Access Compliance Report

Public Rights-of-Way

Intersection ID: 10023890	Main Street: COMMUNITY_HOUSE_RD	Cross Street: N/A	Location: NW
ADA ID: 226BD95BCB58	Ramp Type: Perp	Initial Pass/Fail: Fail	Overall Compliance: No
		Severity Score: 25

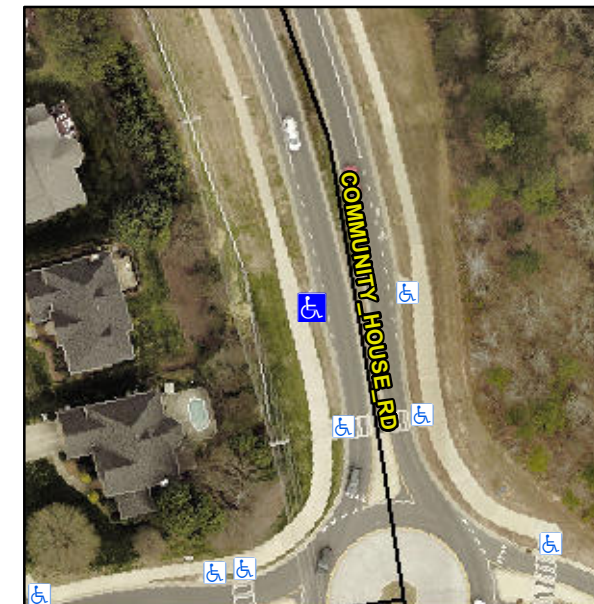
Compliance	Description	Data	Compliance	Description	Data
N/A	Ramp Length (in)	71.0	No	Ramp Slope (%)	14.2
Yes	Ramp Width (in)	111.0	Yes	Ramp XSlope (%)	1.1
N/A	Flare Type LT	N/A	N/A	Flare Type RT	N/A
N/A	Flare Slope LT (%)	N/A	N/A	Flare Slope RT (%)	N/A
N/A	Flare Traversable LT?	N/A	N/A	Flare Traversable RT?	N/A
N/A	Landing Length (in)	N/A	N/A	DWS Provided?	N/A
N/A	Landing Width (in)	N/A	N/A	DWS Contrast?	N/A
N/A	Landing Slope (%)	N/A	N/A	DWS Length (in)	N/A
N/A	Landing X Slope (%)	N/A	N/A	DWS Full Width?	N/A
N/A	Landing Curb? (Y/N)	N/A	N/A	DWS Offset (in)	N/A
N/A	Shared Landing?	N/A			
N/A	Gutter Ponding?	N/A	N/A	Gutter Slope (%)	N/A
N/A	Gutter Lip Ht (in)	N/A	N/A	Gutter X Slope (%)	N/A
N/A	Painted X Walk1?	No	N/A	Painted X Walk2?	N/A
	X Walk 1 Direction	To E		X Walk 2 Direction	N/A
N/A	X Walk 1 Width (in)	N/A	N/A	X Walk 2 Width (in)	N/A
	X Walk 1 Slope (%)	4.3		X Walk 2 Slope (%)	N/A
	X Walk 1 X Slope (%)	1.8		X Walk 2 X Slope (%)	N/A

Remove & Replace Entire Ramp.

R304.2.2
